**UNDERGROUND INJECTION CONTROL
PERMIT APPLICATION**

Ute Tribal # 20-11
1959' FSL & 2033' FWL
Sec. 20, T5S-R3W
Duchesne County, Utah
API # 43-013-34049

Technical Review Worksheet

Well: UTE TRIBAL 20-11

Ute Tribal 20-11 Well History

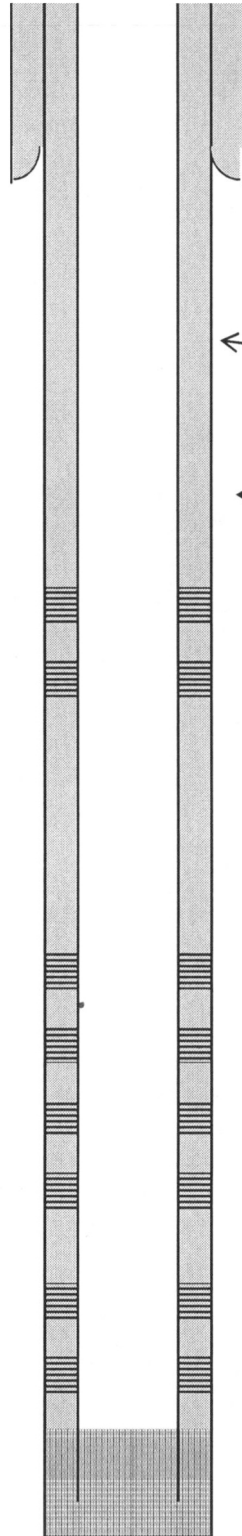
How was USDW DEPTH
DERIVED?
NO CBLS FOR ADR WELLS
MISSING INFO ADR WELL
UT 20-12
NO SURVEY REPORTS
20-11
